METROPOLITAN AREA PLANNING  
COMMISSION

Re: S/D 87-62 - Fairfield Estates 2nd Addition

STAFF REPORT  
(Final Plat)

Re: Final Plat S/D 87-62 - FAIRFIELD ESTATES 2ND

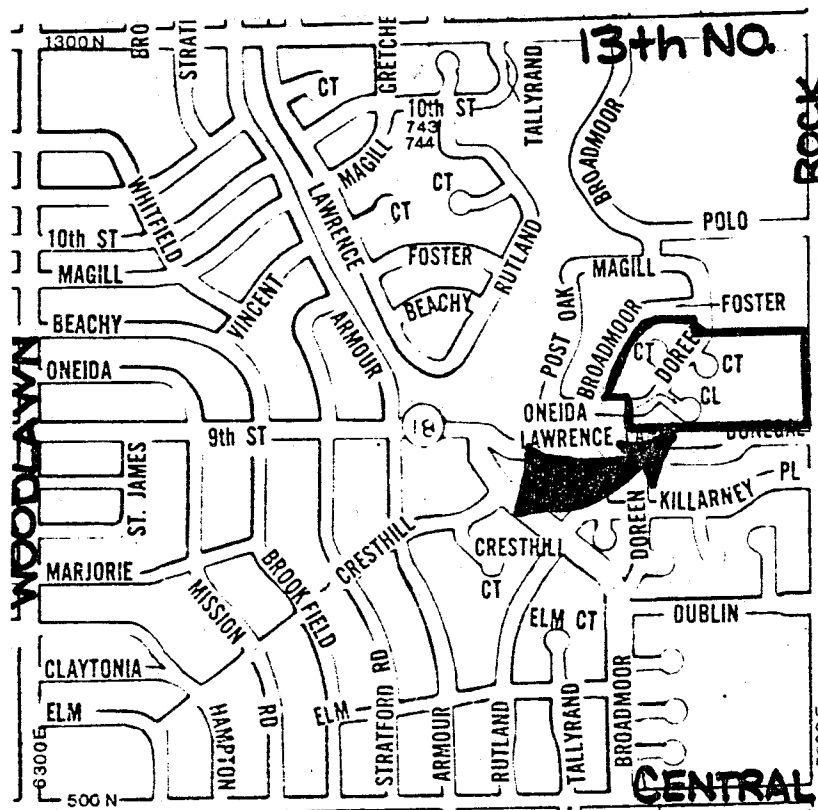
- O. On the final plat, a 25-foot front yard building setback shall be indicated on all lots on Block 4 and Block 6. This is the width of setback depicted on the Associated Community Unit Plan.

- P. On the final plat, the irregular shaped utility easement on proposed lots 5 and 6, Block 6 shall be provided with appropriate dimensions.

- Q. On the final plat, the building setback from Broadmoor Street on lots 1 and 8, Block 3 shall be labeled and dimensioned.
- R. On the final plat, the 15-foot street, drainage and utility easement, on blocks 2 and 3 shall be labeled. The granting of this easement shall be referenced in the plat's text.

- T. The final plat shall provide letter designations for each of the reserves within the perimeter of this plat.
- U. The final plat shall indicate parking easements for the areas proposed for back out parking. These parking easements shall be made as a part of the adjacent reserves. The platting of the parking easements shall be referenced in the plat's text.

- V. The plat's text, on the final plat, shall reference the platting of the proposed wall easements.
- W. The final plat shall label the centerline of the utility easements.

- 1. Broadmoor Court to Oneida Court.
  - 2. 10th Street to 12th Street.
- AA. The final plat shall depict the utility easements requested by K.G. & E and Southwestern Bell.

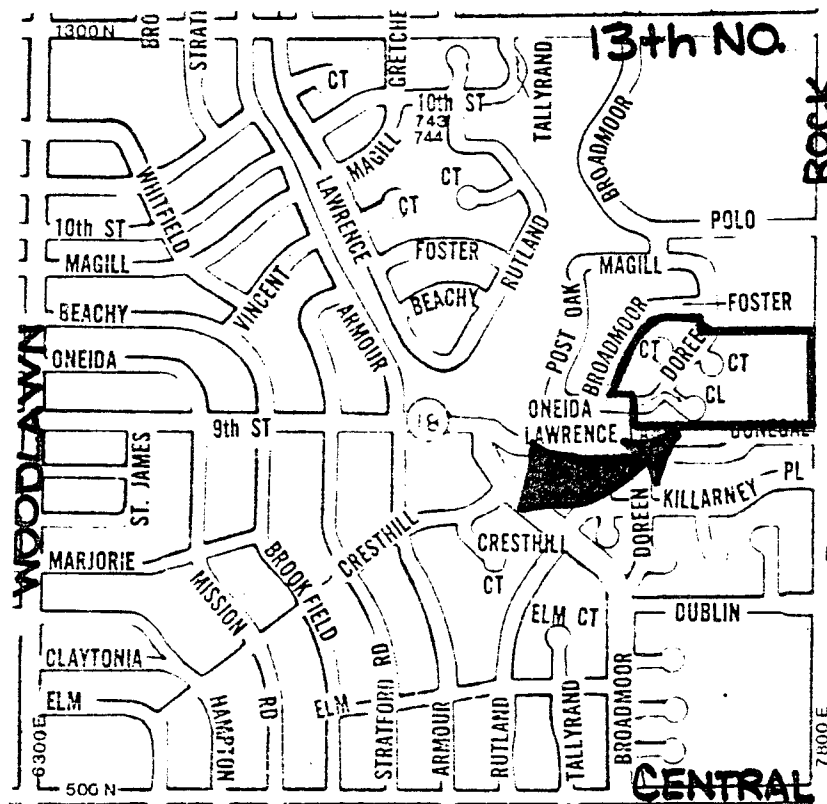
- K. On the final plat tracing, a 25-foot front yard building setback shall be indicated on all lots on Block 1. This is the width of setback depicted on the Associated Community Unit Plan. This setback change was a requirement of preliminary plat approval.

- L. On the final plat tracing, the 10-foot utility easement requested by Southwestern Bell Telephone shall be indicated centered on the common lot line of Lots 18 and 19, Block 1.

- O. The proposed "vehicular access easement," depicted on proposed Lot 4, Block 2, shall be established by separate instrument. This easement shall be recorded prior to completing the plat so appropriate recording information may be indicated on the final plat tracing. The instrument establishing the easement shall clearly reference which property benefits from the easement, who is responsible for maintenance of the driving surface and who is responsible for initial construction of the driveway. A copy of the recorded easement shall be submitted for the plat file.
